## *City of El Paso – City Plan Commission Staff Report*

**Case No:** SUSU14-00120 Mesa Hills Unit 2 Replat B  
**Application Type:** Resubdivision Combination  
**CPC Hearing Date:** February 12, 2015  
**Staff Planner:** Joaquin Rodriguez, (915) 212-1608  
[rodriguezjx3@elpasotexas.gov](mailto:rodriguezjx3@elpasotexas.gov)  
**Location:** North of Mesa Hills, East of Kingsfield  
**Acreage:** .469  
**Rep District:** 1  
**Existing Use:** Residential  
**Existing Zoning:** R-3  
**Proposed Zoning:** R-3  
**Nearest Park:** Galatzan Park (1.68 mi)  
**Nearest School:** Green Elementary (.5 mi)  
**Park Fees Required:** \$2740.00  
**Impact Fee Area:** N/A  
**Property Owner:** Nora A Crowley  
**Applicant:** Nora A Crowley  
**Representative:** Dorado Engineering

**MESA HILLS SUBDIVISION  
UNIT TWO REPLAT "B"**

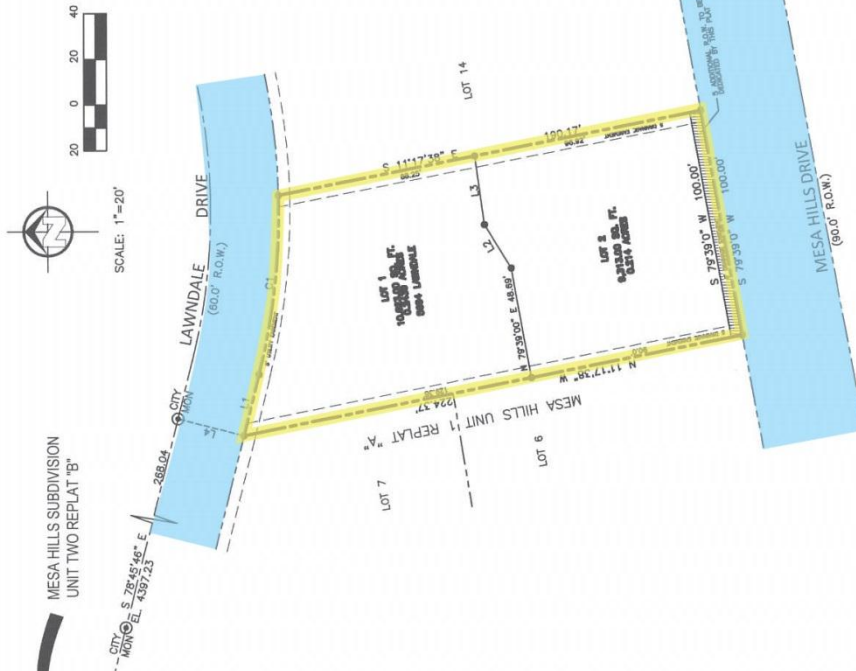
The applicant proposes direct vehicular access to Mesa Hills Drive. The previously recorded plat, Mesa Hills Unit 2 Replat A restricted direct vehicular access to Mesa Hills Drive through a separate instrument and a note referencing said instrument on the face of the plat. Any modification or release of this restriction would require the entirety of Mesa Hills Unit Replat A to be vacated and subsequently replatted.

1. On Location Map, correct the name of the streets adjacent to the subdivision.
2. Provide written confirmation that the adjacent property owner (lot 1) accepts runoff from the proposed lot 2.
